CF34 TURBOFAN (BUSINESS JET)

ALERT SERVICE BULLETIN

OIL - Lube and Scavenge Components (79-00-00) - Field Management Program to Prevent B-sump Oil Release Events

SERVICE BULLETIN (CF34-BJ) 79-A0015, REVISION 1

Inspection of Scavenge Filter Screen Bulkhead Tee PN 5054T86G02
Figure 1

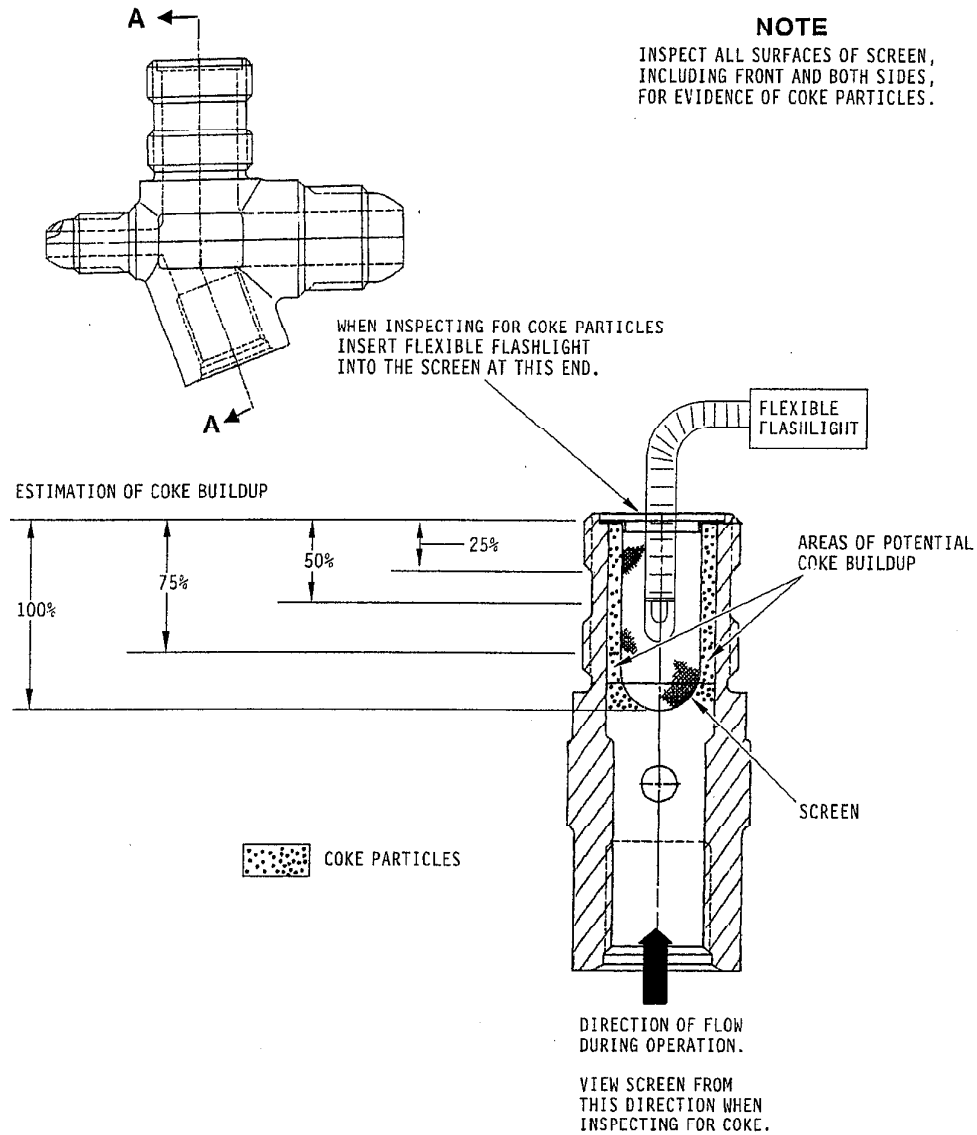
screen toward the light source. Be sure to inspect the entire screen, including both sides of the cone-shaped screen, for coke particles. Refer to Figures 1 and 2.

- (c) Record whether there is any evidence of coke particles accumulated in the screen. If coke is present in the screen, record screen blockage percentage (refer to Figure 1 for interpretation). GE requests that the screen blockage data be provided to GE via your local GE rep, assigned Product Support Engineer, or Customer Support Manager. Include screen blockage percentage, ESN, TSN/CSN, and date of inspection.
- (d) Clean the tube screen insert nipple (79-00-00-10-265) and the scavenge filter screen bulkhead tee (79-00-00-10-315A) or obtain a new or previously cleaned tube screen insert nipple (79-00-00-10-265) and the scavenge filter screen bulkhead tee (79-00-00-10-315A). To clean the screens, do as follows:
 - 1 Loosen and dislodge the coke particles as much as possible with a dental pick or equivalent tool.

Inspection of Tube Screen Insert Nipple PN 4047T95P01
Figure 2

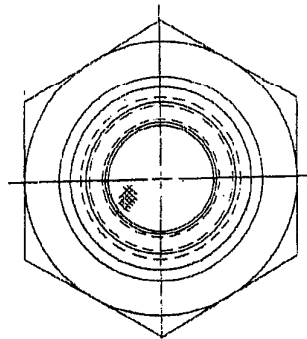
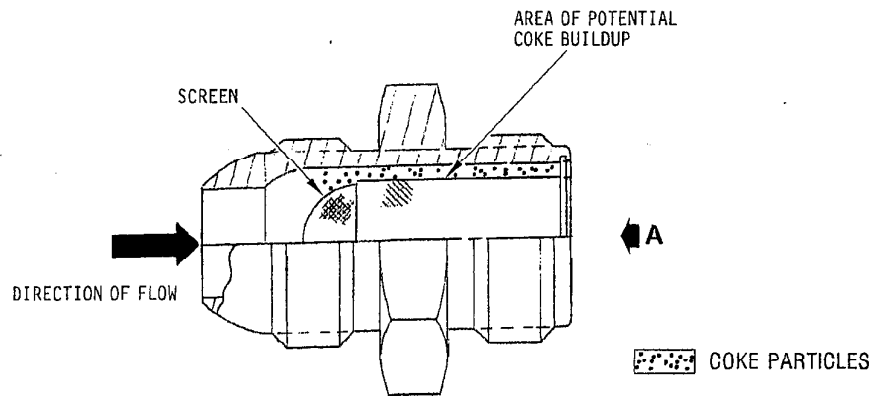
INSPECT ALL SURFACES OF THE SCREEN, INCLUDING FRONT AND BOTH SIDES, FOR EVIDENCE OF COKE PARTICLES.
